City of Portland, Maine – Building or Use Permit Application 389 Congress Street, 04101, Tel: (207) 874-8703, FAX: 874-8716

Location of Construction: 41 Edgeworth Avenue		Owner: Kelly and Scott Dover		Phone: 871-8966		Permit No: 970616	
Owner Address:		Lessee/Buyer's Name:		Phone:		Business Name:	
Contractor Name:		Address:		Phone:		<div style="border: 2px solid black; padding: 5px; text-align: center;"> PERMIT ISSUED Jun 19 1997 CITY OF PORTLAND </div>	
Past Use: garage		Proposed Use: same w/repairs		COST OF WORK: \$500.00 FIRE DEPT. <input type="checkbox"/> Approved <input type="checkbox"/> Denied Signature:		PERMIT FEE: \$25.00 INSPECTION: Use Group: Type: Signature:	
Proposed Project Description: make repairs to existing garage as per plans				PEDESTRIAN ACTIVITIES DISTRICT (P.A.D.) Action: <input type="checkbox"/> Approved <input type="checkbox"/> Approved with Conditions <input type="checkbox"/> Denied Signature: Date:			
Permit Taken By: Vicki Dover		Date Applied For: 6/12/97

REASON FOR PERMIT: Repair existing garage

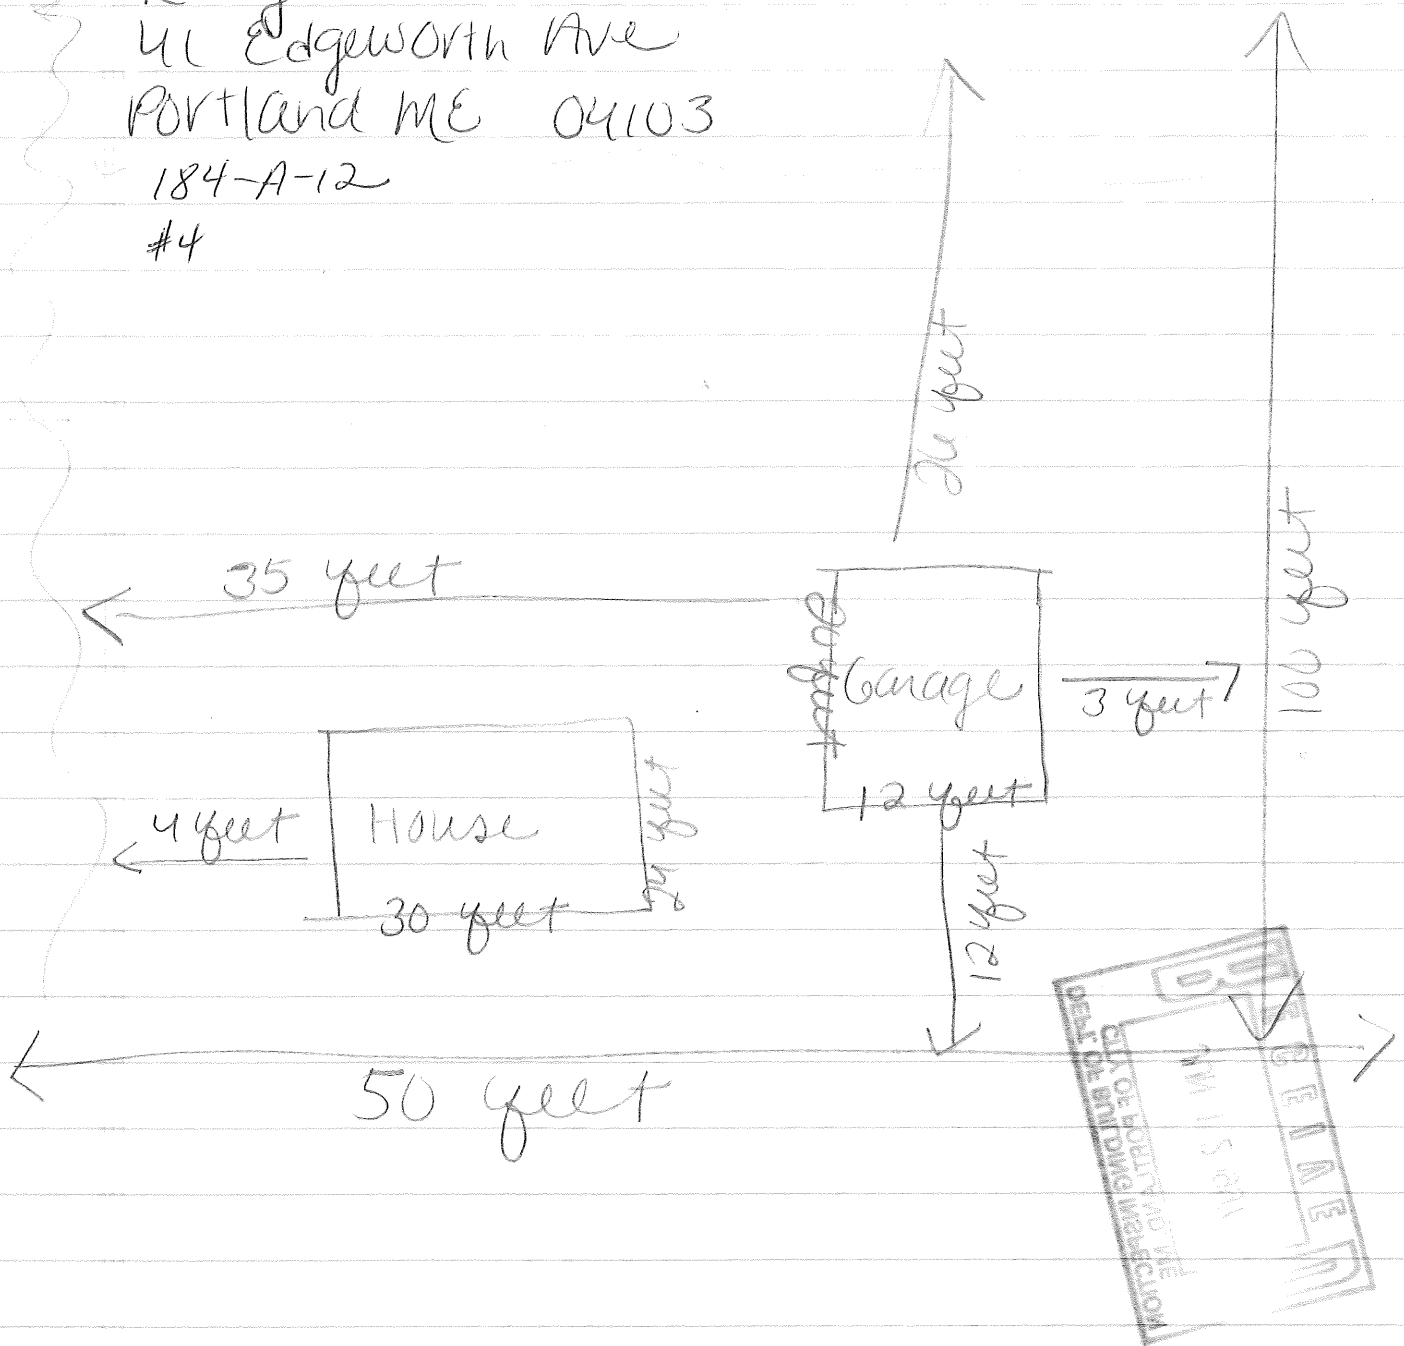
We will be repairing our garage. The garage was built on top of a ~~t/r~~ driveway. The ~~t/r~~ has given way on the sides and the bottom boards of the garage have rotted causing garage to lean.

The boards in the garage going up and down are 23 ~~i~~ches on the center. The side walls are tounge and groove 7 1/2 boards.

We will jack up the garage and replace 4 of the 7 1/2 tounge and groove boards around the bottom. We also will pour a cement slab underneath. The ~~t/r~~ has given away and this will prevent the bottom boards from rotting again. If we can not afford the cement slab, then we will put some cement blocks along the ~~u~~nderneath so that the bottom of the garage will not be sitting on the ground.
